INSTALLATION DIAGRAM STANDARD PIER TOP PLATE

ADDENDUM

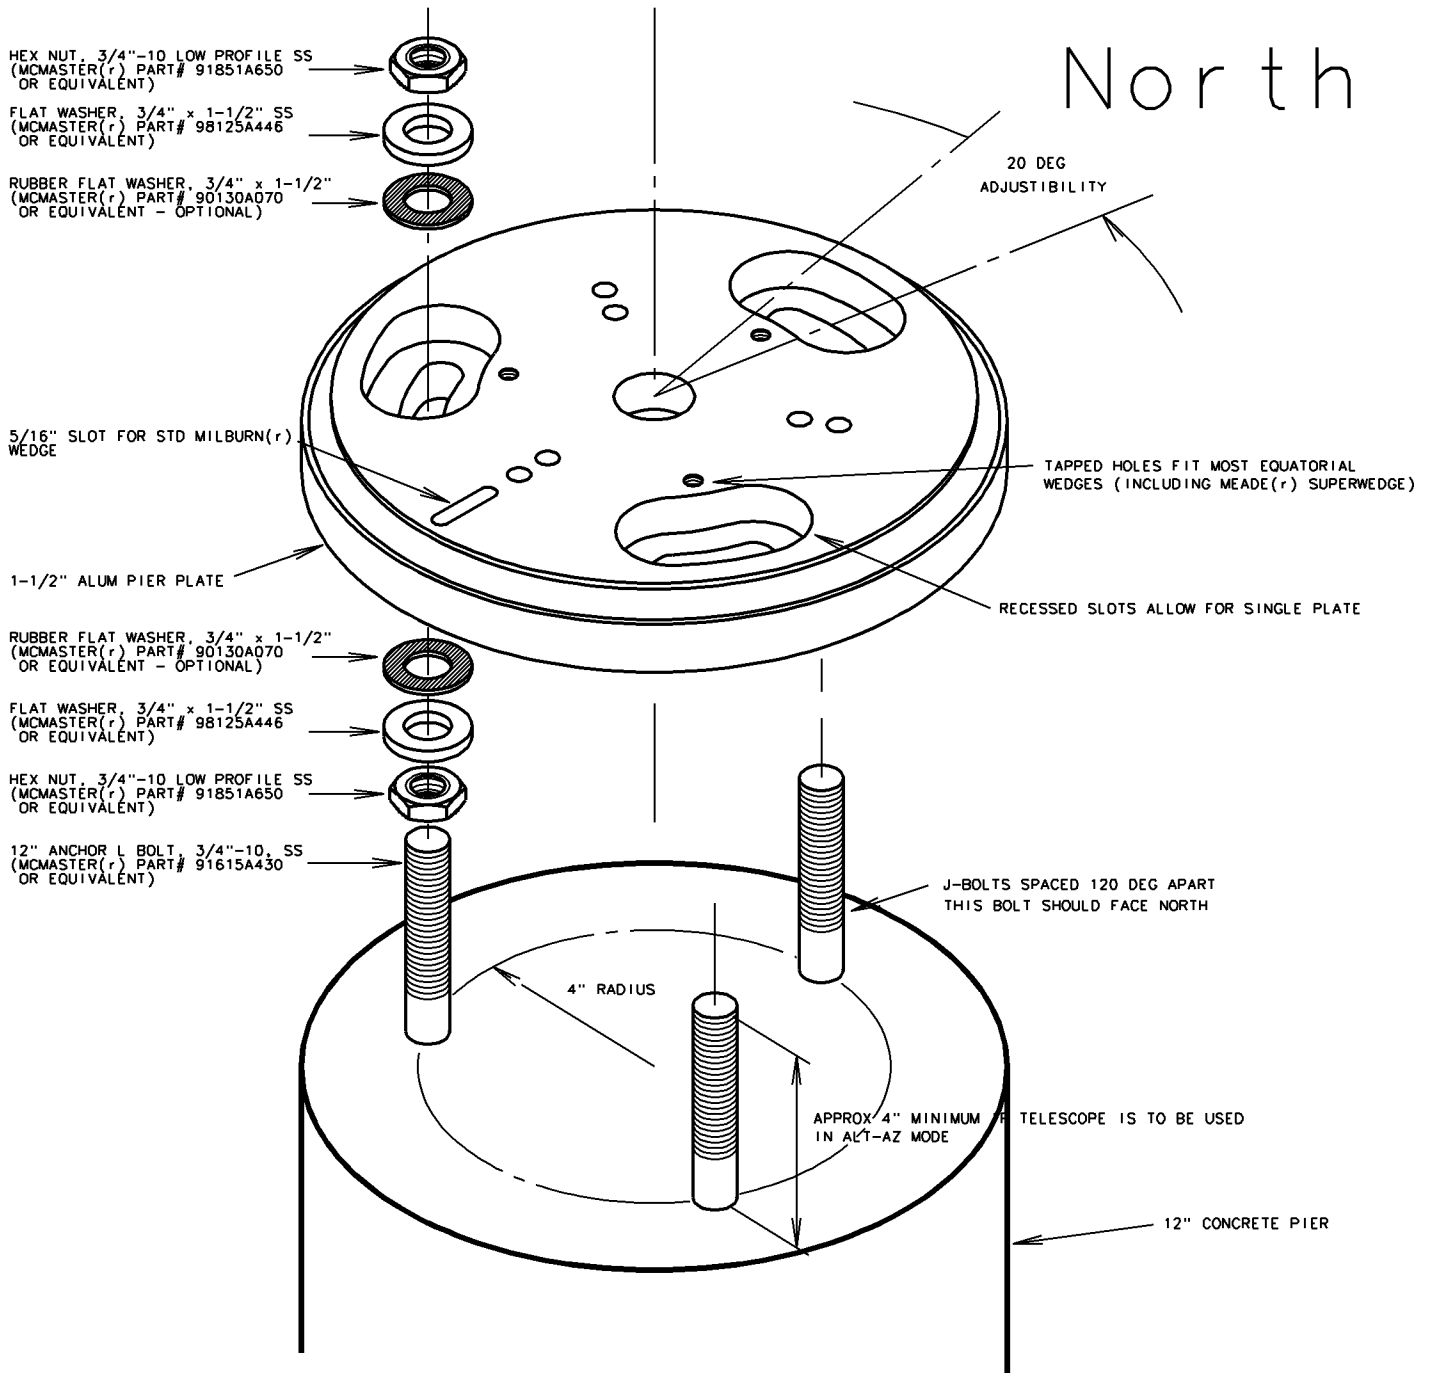
MANY CUSTOMERS HAVE ASKED US TO ENLARGE THE SIZE OF THE MOUNTING SLOTS OF OUR 12" PIER TOP PLATES TO MAKE UP FOR IMPERFECT BOLT ALIGNMENT. ALL 12" PLATES NOW HAVE WIDER MOUNTING SLOTS AND ALSO INCLUDE AN OPTIONAL BRONZE SLEEVE BEARING THAT SLIDES OVER THE ANCHOR BOLT TO PROTECT THE PLATE FROM THE ANCHOR BOLT THREADS. IF MORE LEEWAY IS NEEDED TO MOUNT THE PLATE, THE BRONZE SLEEVE BEARING MAY BE OMITTED.

BRONZE SLEEVE BEARING
(INCLUDED IN NEW 12" PIER
TOP PLATES)
